Anonymous Referee 2:

The paper introduces a microlysimeter for the specific purpose of measuring the deposition of water on the surfaces of the soil and the vegetation by means other than rain (dew, fog, etc.). The deposited amounts of water are quite small, yet the paper argues that they could be important for the vegetation during dry periods. The design of the set-up, with its high observation frequency and high-resolution mass measurements is explained in some detail. The instrument has been in operation in the field. Its performance is reported and evaluated.

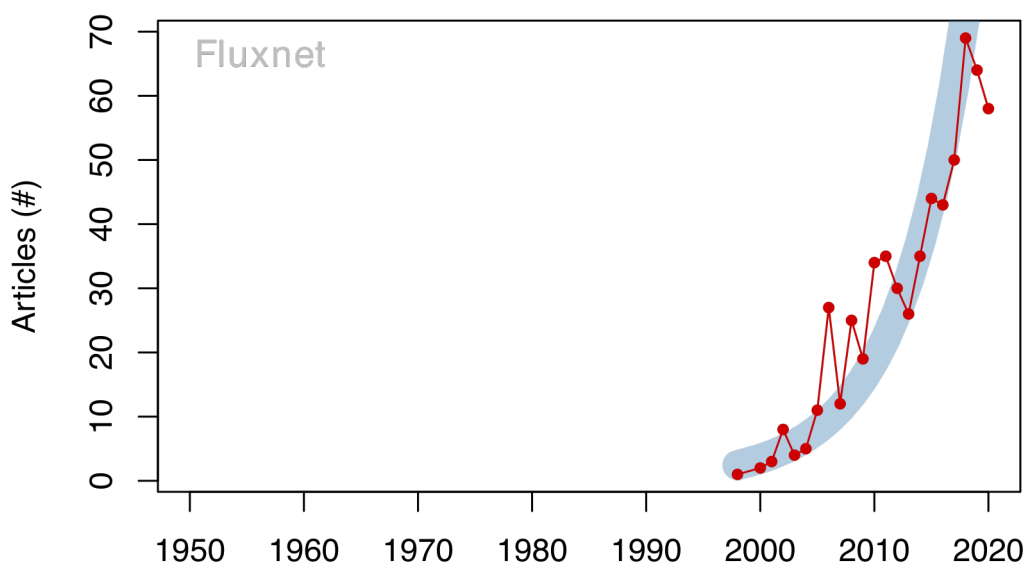
L124: What is FluxNet? Do we need to know?

This is part of the site information to tell readers in which network this site is embedded. Below is a statistics extracted from the Scopus database on the increasing importance of FluxNet in the field of eddy covariance flux measurements of H₂O and CO₂ fluxes. It is thus not surprising that the name is new to some readers, but this might change rapidly if the spread of FluxNet data usage continues at its current pace. Thus, we prefer to keep this information and expect that readers not interested in it will simply ignore.

Source: <https://www.opto22.com/support/resources-tools/demos/accuracy-vs-resolution>

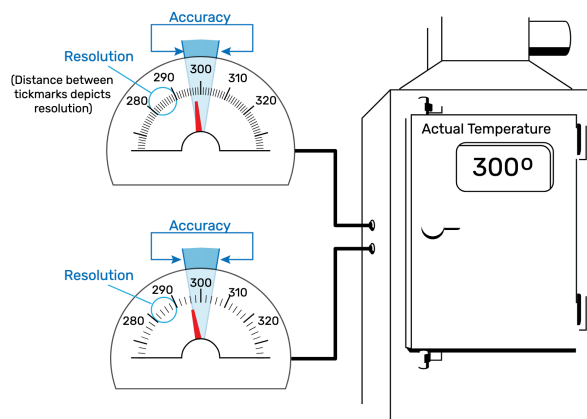
Section 4.1: I believe you mean resolution instead of accuracy.

In our understanding accuracy is “how close a reported measurement is to the true value being measured.” (<https://www.opto22.com/support/resources-tools/demos/accuracy-vs-resolution>). The reported measurements are in our case the readings from the microcontroller and the true values stem from the calibration mass as they are used to calibrate commercial scales in grocery stores and elsewhere. We define the term “accuracy” in the introduction: “In this study, weighing accuracy denotes the difference between the measured mass (determined with a ML) and the control (calibrated mass).”. “Resolution is the smallest change that can be measured.” (<https://www.opto22.com/support/resources-tools/demos/accuracy-vs-resolution>). So, resolution must be smaller than the accuracy, we report a resolution of 0.0002 mm. In the text we will carefully check the correct usage of accuracy vs. precision. Where a calibration with calibrated mass was possible we will retain the term accuracy. In cases where an absolute standard could not be used, we will adopt the term “precision” instead.
